Bureau of Alcohol, Tobacco,  
Firearms and Explosives

This is in reference to your correspondence to the Bureau of Alcohol, Tobacco, Firearms and Explosives (ATF), Firearms Technology Branch (FTB), which accompanied your prototype sample of an AR-10 type receiver blank your company intends to manufacture and market. Specifically, you requested an examination and classification of the submitted sample pursuant to the amended Gun Control Act of 1968 (GCA) and asked if it would be regulated as a "firearm" under the GCA.

**Submitted prototype sample**

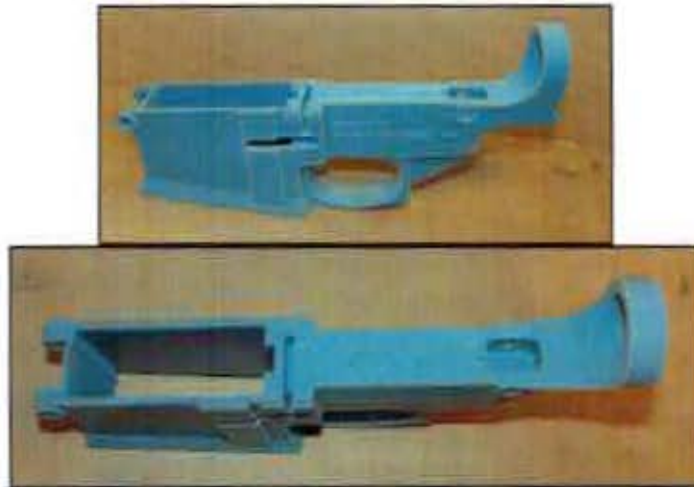
Our examination of the submitted item confirmed that the receiver blank has been partially machined, including a takedown pin hole and clearance for the takedown-pin lug. Our examination confirmed that the takedown-pin lug clearance area is less than 1.6 inches, measured from immediately forward of the front of the buffer-retainer hole (see photos below). The sample is completely solid and un-machined in the fire-control recess area and, accordingly, is not a "firearm" as defined in the GCA.
